SUNDRY NOTICES AND REPORTS ON WELLS

1. Type of Well <input type="checkbox"/> Oil Well <input type="checkbox"/> Gas Well <input checked="" type="checkbox"/> Other		5. Lease Serial No. NM54865
2. Name of Operator St. Mary Land & Exploration Company		6. If Indian, Allottee or Tribe Name
3a. Address 3300 N. A St., Bldg 7, Ste. 200, Midland, TX 79705	3b. Phone No. (include area code) 432-688-1789	7. If Unit or CA/Agreement, Name and/or No.
4. Location of Well (Footage, Sec., T., R., M., or Survey Description) (1) Sec. 35 - T19S-R29E 2610' FSL & 430' FEL		8. Well Name and No. PIDU #703
		9. API Well No. 30-015-30027
		10. Field and Pool, or Exploratory Area Parkway, Delaware
		11. County or Parish, State Eddy Co., N.M.

Proposed P&A Procedure
Parkway Delaware Unit #703

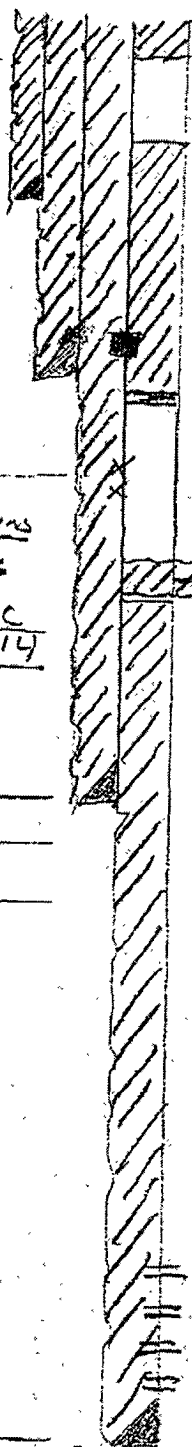
* Submit Subsequent Reports from
Previous workover efforts that have
us at this point. Red. Well No
Reports submitted. Back to 3/12/98.

Plug from CIBP @ 1550'
to 302'. Secretary Potash.
Solid Plug thru Salt Sect.
Covers DVT and Surf.
Shoe. WDC Tag 302'.

302 WOL Tag

WOL Tag.

4 1/2" stub
50' in/out
